SUBJECT: ELECTRICAL (COCKPIT), INSPECTION OF THE WIRING TO THE OVERVOLTAGE RELAY

AIRCRAFT AFFECTED: BEECHCRAFT Musketeers, Model A23, A23A, and B23, serials M-555 through M-1104; Model 19 and 19A, serials MB-1 through MB-337; Model 24, serials MA-1 through MA-317.

FIGURE 1
SERIALS M-555 THRU M-903

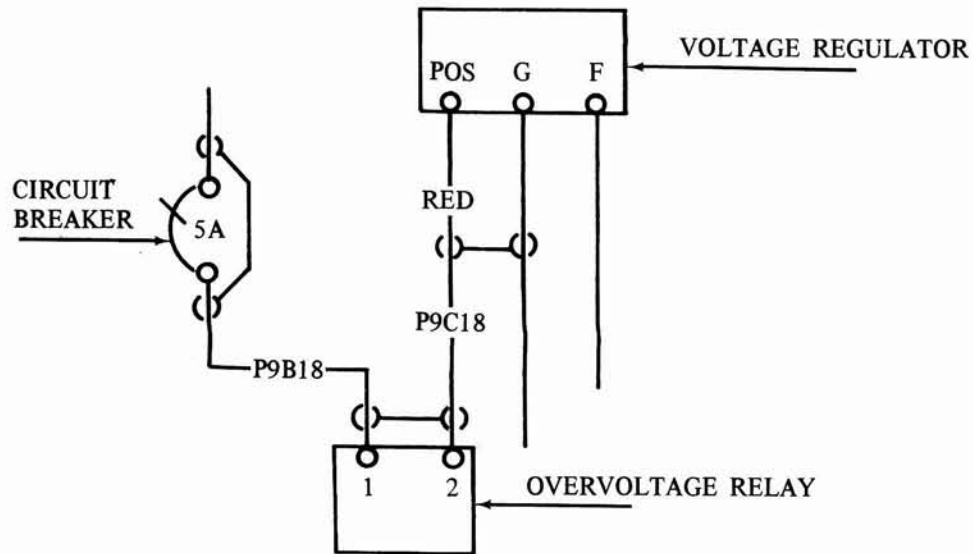
On BEECHCRAFT Musketeers, models and serials noted above, it is suggested that the wiring to the overvoltage relay be inspected within the next 100 hours to ensure connection to the proper terminals, as shown in figures 1 and 2.

Figure 1 applies to serial numbers M-555 through M-903. Figure 2 applies to serial numbers M-904 through M-1104, MB-1 through MB-337, and MA-1 through MA-317.
